From: Kefetew Selassie [REDACTED]
Sent: Tuesday, January 21, 2020 7:20 PM
To: Bertron, Cara; James Nolan; Desta Selassie
Subject: Re: 607 Oakland Avenue- Pictures

From: Bertron, Cara <Cara.Bertron@austintexas.gov>
Sent: Tuesday, January 21, 2020 4:14 PM
To: Kefetew Selassie; James Nolan; Desta Selassie
Subject: RE: 607 Oakland Avenue- Pictures

From: Bertron, Cara
Sent: Tuesday, January 21, 2020 3:54 PM
To: Kefetew Selassie [REDACTED]; James Nolan <james@jamesnolanconstruction.com>; Desta Selassie [REDACTED]
Subject: RE: 607 Oakland Avenue- Pictures

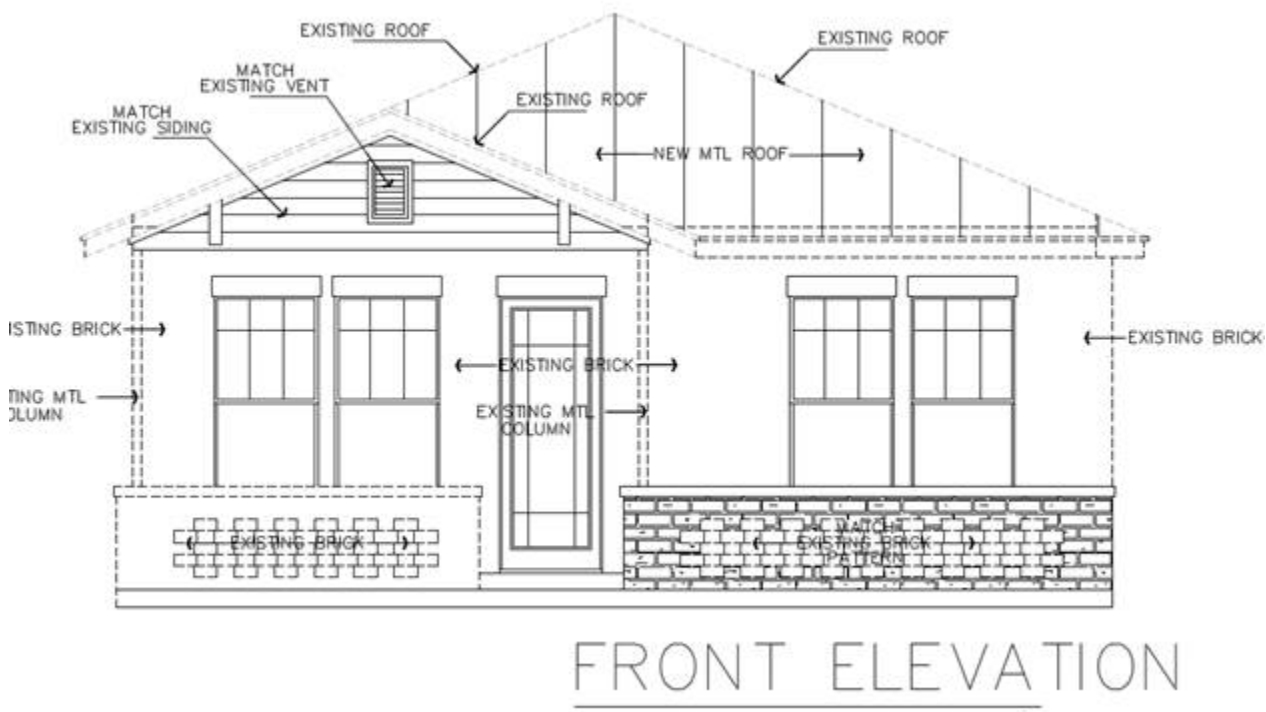
An important revision to #3. I hadn't looked closely at the patio/porch extension, assuming it was the one we'd discussed in early July. Upon closer review, I see that the current proposal extends the porch roof and changes the column and railing types. The column and railing alterations may be possible, especially since with the proposed brick removal—though wood railings would be more appropriate.

Original (July 2019):

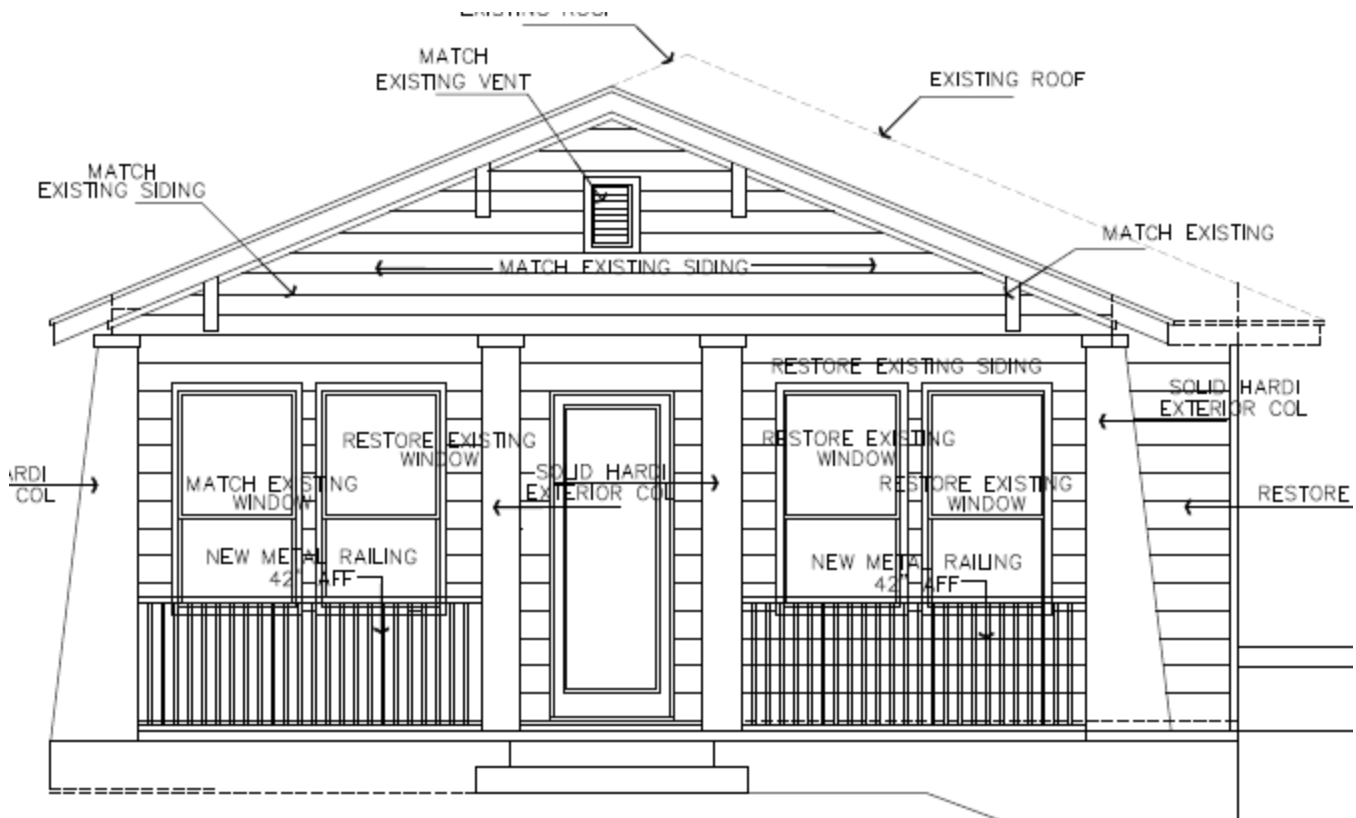
However, the porch should stay at its current footprint. Expanding it will add a new feature that wasn't there historically and suggest a false sense of the building's development. If you'd like to extend an uncovered patio across the right side of the front wall, that's an option I can support.
